INDEX OF SHEETS

# PROPOSED IMPROVEMENT INTERSECTION PROJECT TOWN OF HARTLAND COUNTY OF WINDSOR THREE CORNERS INTERSECTION

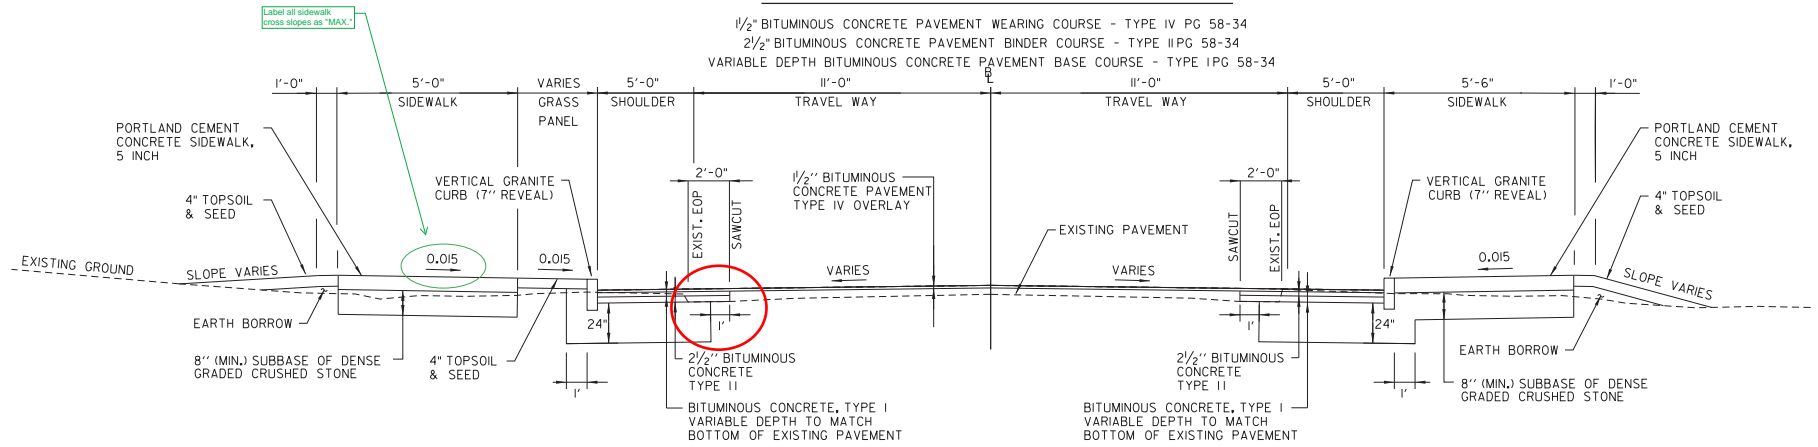
VHB RESPONSE: LEAVE AS IS. 2% IS THE MAX. WE WANT TO DIRECT THE CONTRACTOR TO SHOOT FOR 1.5%

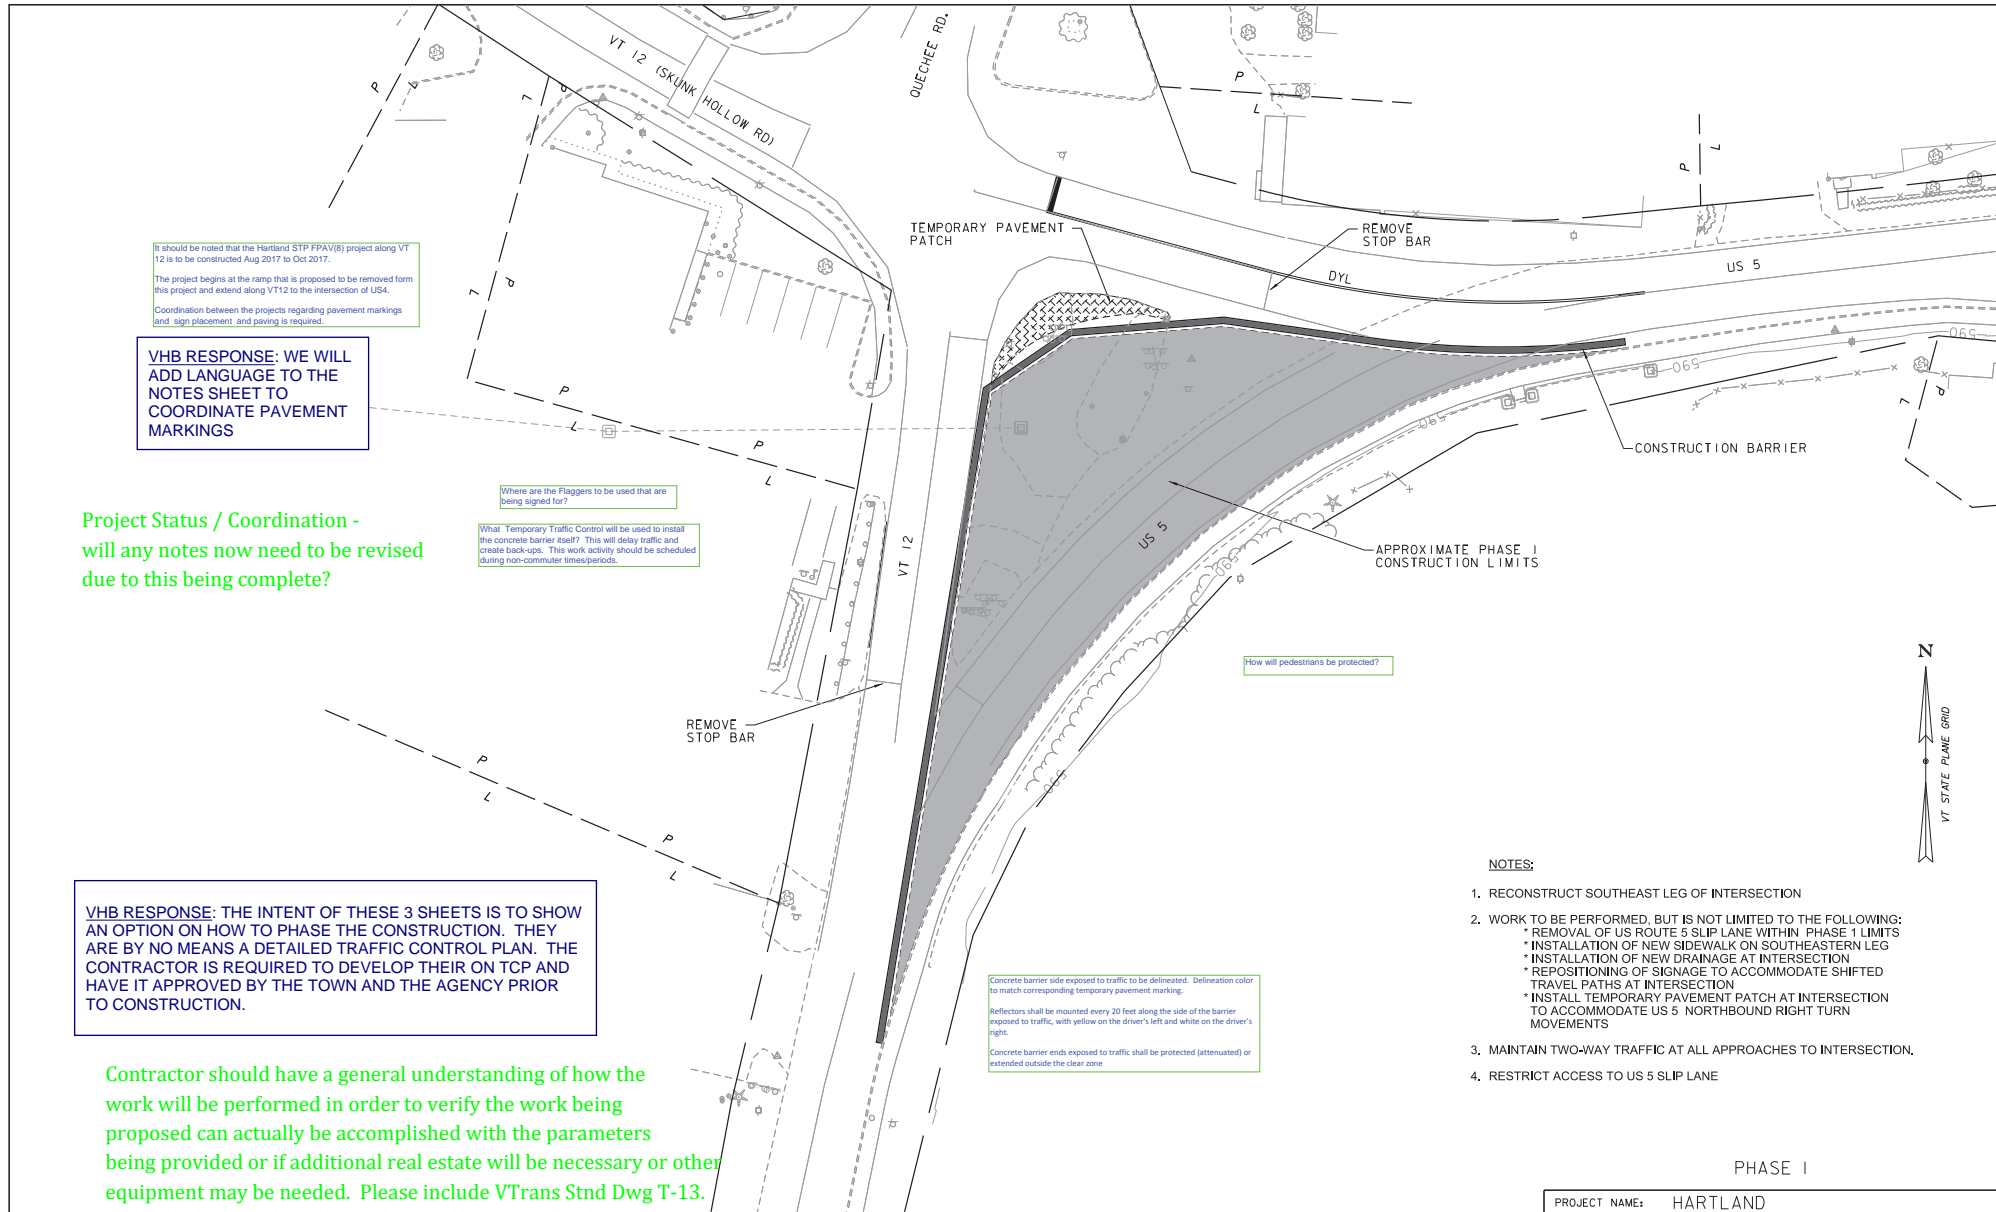
**VHB RESPONSE: THE INTENT OF THESE 3 SHEETS IS TO SHOW AN OPTION ON HOW TO PHASE THE CONSTRUCTION. THEY ARE BY NO MEANS A DETAILED TRAFFIC CONTROL PLAN. THE CONTRACTOR IS REQUIRED TO DEVELOP THEIR ON TCP AND HAVE IT APPROVED BY THE TOWN AND THE AGENCY PRIOR TO CONSTRUCTION.**

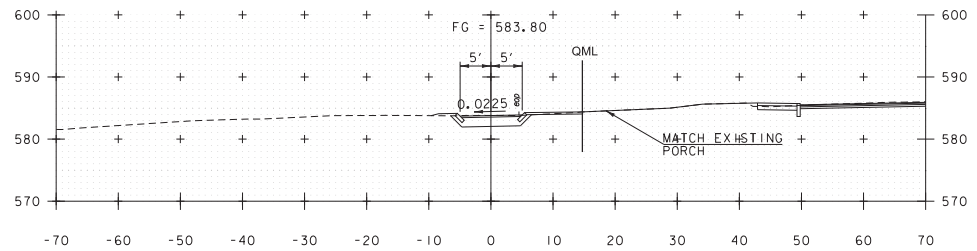
VHB RESPONSE: THIS IS NOT AN AOT PROJECT AND WE ARE NOT REQUIRED TO ADHERE TO AOT STANDARDS

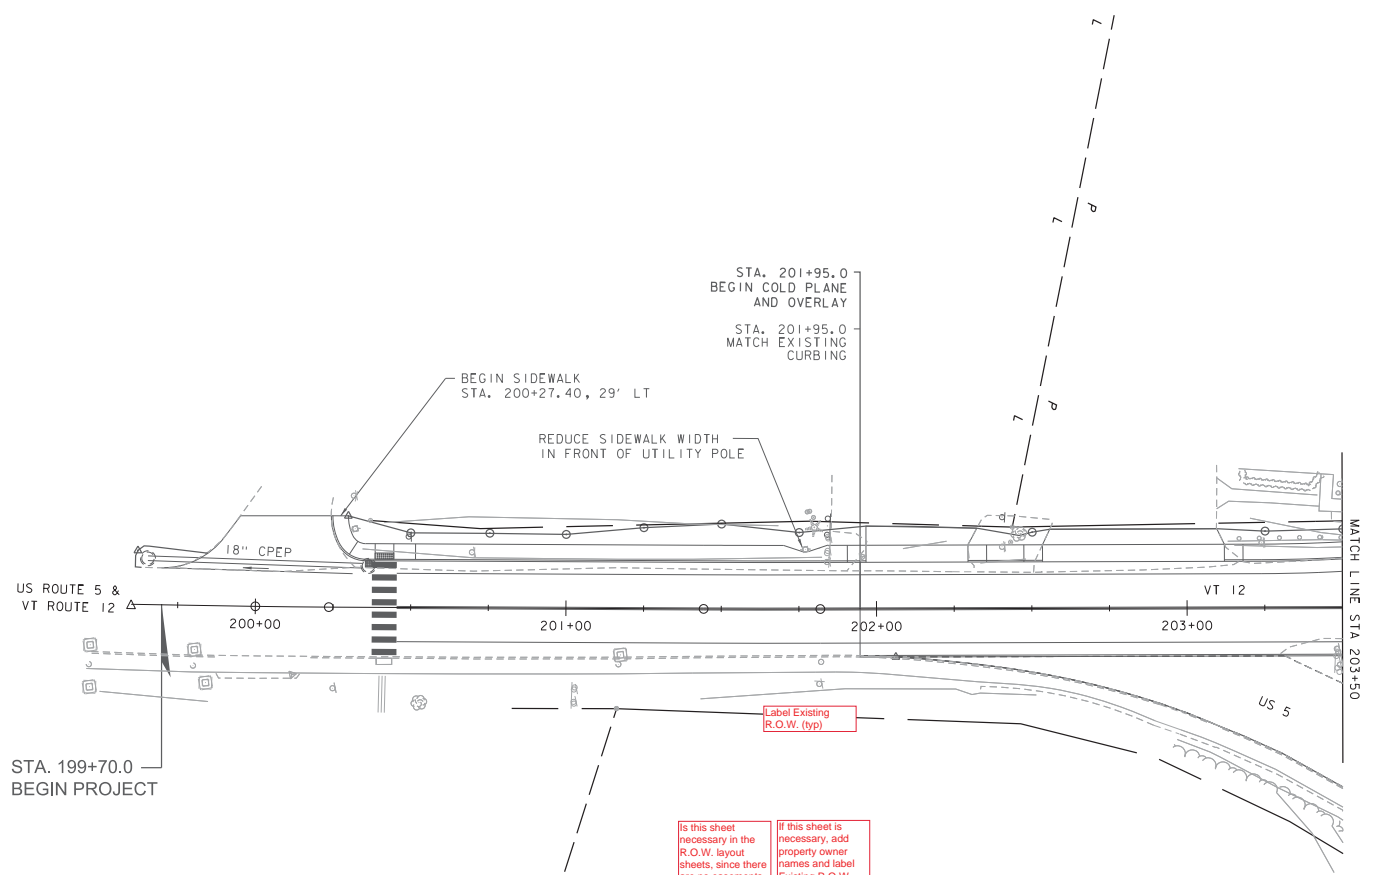
**VHB RESPONSE: THIS IS NOT AN AOT PROJECT AND WE ARE NOT REQUIRED TO ADHERE TO AOT STANDARDS**
